Information Required to Discharge Outstanding Conditions in Relation to Listed Building Consent Reference: CDN/23/0065 [Condition numbers – 4, 6, 9, 13, 16, 17, 18 & 22] and Planning Permission Reference: CDN/23/0064 [Condition numbers – 3, 7, 15 & 16] for the Adaptation of Fenton House, Higher Ardwick into Seven Apartments.

Introduction and Schedule of Information for Condition Compliance

*Peter Jones-Hughes and Huw Davies
MIHBC; BSc Hons Town Planning; PG Dip Blg Cons [RICS]
Prepared November 2024 – Version 3*

**Proposed Traditional Type External Ventilation Grilles.
[Part Detail Compliance with Conditions 3 of the Planning Permission – 23/0064
& 4 Listed Building Consent - 23/0065 – See also Plan 1]**

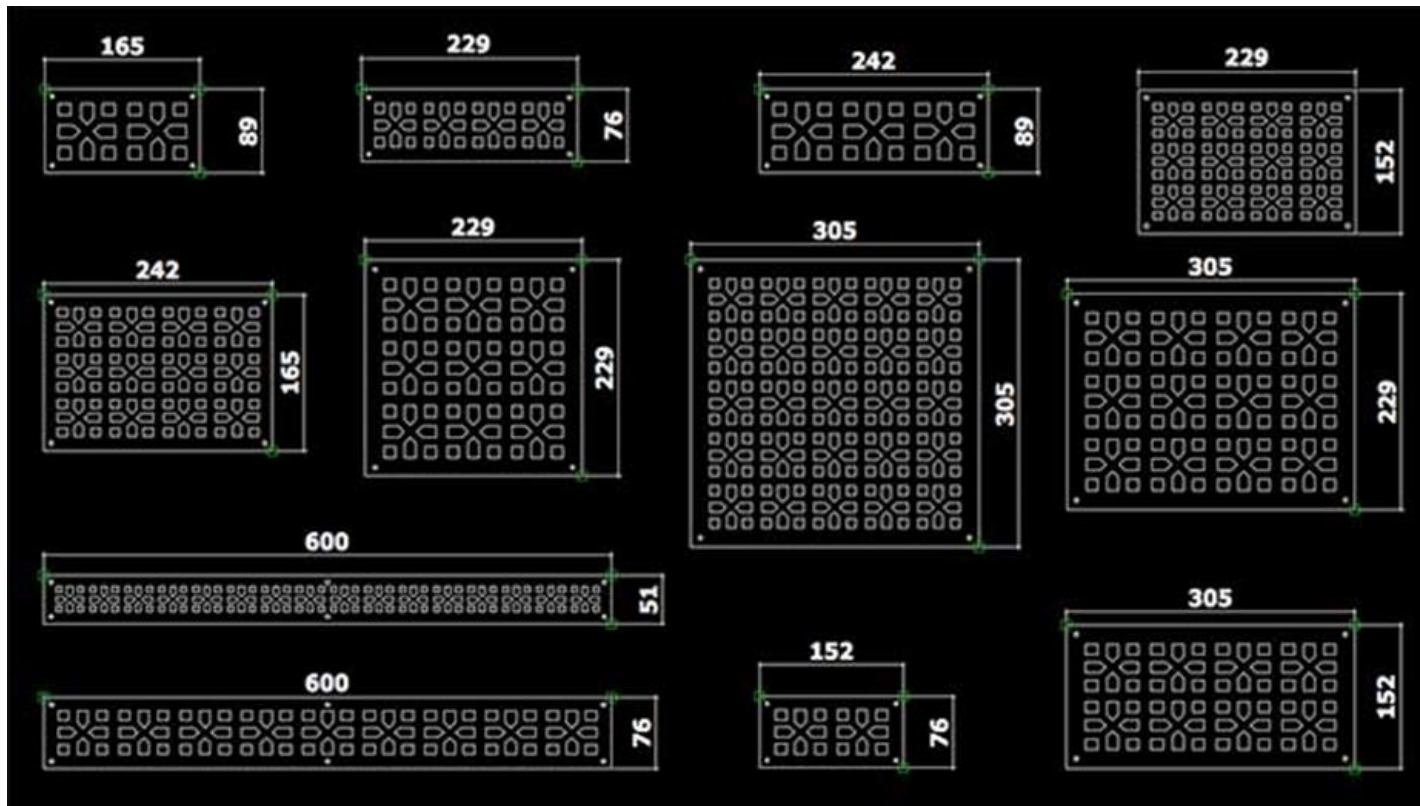
MCC requirements are to show the positions of the external vents and the detailed design of the vent grilles. Further consideration indicates that it is not practical to utilise the existing chimney flues for ventilation routes. An alternative approach is now presented, and the proposed positions of external ventilation grilles are shown on revised 'as proposed' plans and elevations.

repairs will be made available for inspection on site. h) External extraction fan outlets/vent grilles. Product details of these are included in Appendix F of this document and revised plans/elevations showing the locations of the vent outlets are shown in separate PLAN 1. i) New external lighting units. [See Previously submitted Documents page of Doc 4] – Product details of these are included in Document I j) Roof Insulation - Although there were details of the work to be undertaken to the chimney stacks and roof [slates etc] covered by condition, these are now completed. Planning officers may wish to take the opportunity to have a look at these elements when they visit the site. The details of the installed insulation and accompanying method statement are included in Document 2 k) Rainwater goods – These are proposed to be cast iron in Steel Blue colour [eggshell?] Product details of these are included in Document I l) Stonework - The existing internal stone floor covering in the upper ground floor corridor has been repaired by a specialist mason restorer. m) Railings product details.	j) <u>Document 2 for Roof Insulation Details/Method Statement.</u> m) <u>Document 3 for details of railings and paint analysis results.</u>
